Office Action Summary

10/599,816

HWANG ET AL.

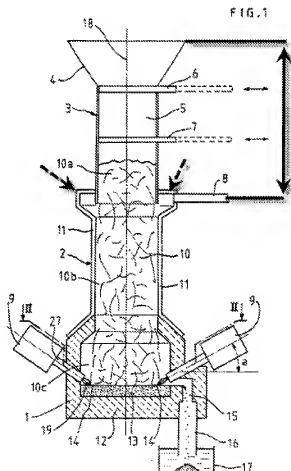
3. '944 discloses a cyclonic plasma pyrolysis/vitrification system pyrolyzing and vitrifying waste materials into exhaust gas and slag using a plasma torch, the system comprising: a main reactor (10) having a waste inlet (18) supplying waste materials, an exhaust gas outlet (8) discharging exhaust gas, and a slag outlet (15) discharging slag (13); a plasma torch (9) inclined at a predetermined angle (a) with respect to the internal bottom surface (12) of the main reactor (10) to give a maximum circulating power to the exhaust gas (Col. 7, lines 66-68; Col. 8, lines 1-2), pyrolyzing and vitrifying the waste materials (Col. 1, lines 1-2); a slag discharger (17) connected to the slag outlet (15) of the main reactor (10), discharging the slag (13) to the outside; wherein the plasma torch (9) circulates the exhaust gas in the main reactor (10) with a maximum circulating power by strong plasma jet (Col. 7, lines 66-68; Col. 8, lines 1-2), and makes flyashes contained in the circulating exhaust gas to be melted after being absorbed into melted materials of waste materials in both inner walls (1) and bottom surface (12) of the main reactor by a centrifugal force (Col. 3, lines 47-48), wherein the slag discharger (17) is

formed just under the plasma torch (9), wherein the plasma torch (9) is inclined at the angle (a) ranging from 20 to 40 degrees with respect to the bottom surface (12) of the main reactor (10) (Col. 5, lines 1-4), wherein the cyclonic plasma pyrolysis/vitrification system includes a waste inlet (18) and an exhaust gas outlet (8) having a designated distance therebetween in the main reactor (see unbroken arrow on Fig. 1 below), and further including a separator wall with a designated length formed therebetween (See broken arrows on Fig. 1 below).
